Office Action Summary

Application No.	Applicant(s)	
10/772,386	TAMAMOTO, JUNICHI	
Examiner	Art Unit	
RAKESH KUMAR	3651

DETAILED ACTION

Kawasaki Figure 17

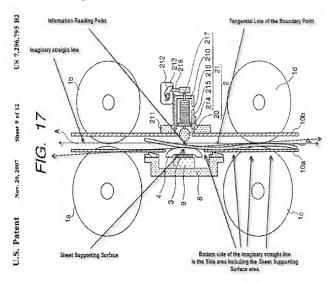
In regards to applicants arguments "when seen in a view direction that is perpendicular to the thickness direction of the sheet and the transfer direction of the sheet transfer member, a tangential line of the boundary point of the transfer surface of the sheet transfer member from which the sheet starts to separate away from the transfer surface extends in an area of an imaginary straight line passing the information reading point and the boundary point with the side area including the sheet supporting surface area. The tangential line intersects the sheet supporting surface area as seen in the view direction to press the sheet against the sheet supporting surface area." (See Figure below)

Applicant further argues "Contrary to the present invention, Kawasaki provides no disclosure or suggestion for a structure that would enable a sheet having a straight shape to be pressed against the sheet supporting surface area by the sheet transfer member when the information is read from the sheet at the information reading point in

the information reading range. Rather, Kawasaki only provides a structure wherein the sheet must necessarily be curved or bent in order to be pressed against any surface."

In view of the Office, the sheet prior to entering the apparatus of Kawasaki as shown Figure 17 and above is in a straight shape. However, once entering the apparatus the sheet is bent to be pressed against the sheet supporting surface, which is clearly shown in the Kawasaki Figure 17.

It is not clear whether the applicant is suggesting that the applicants invention does not bent the sheet in order to press the sheet against the sheet supporting surface. If this is such a case, the Office responds that the above limitations are not positively disclosed in claim 1, and further the Office suggests the applicant review the applicants drawing Figures 4-13 wherein the applicant shows a bent sheet in the apparatus and not a straight sheet.
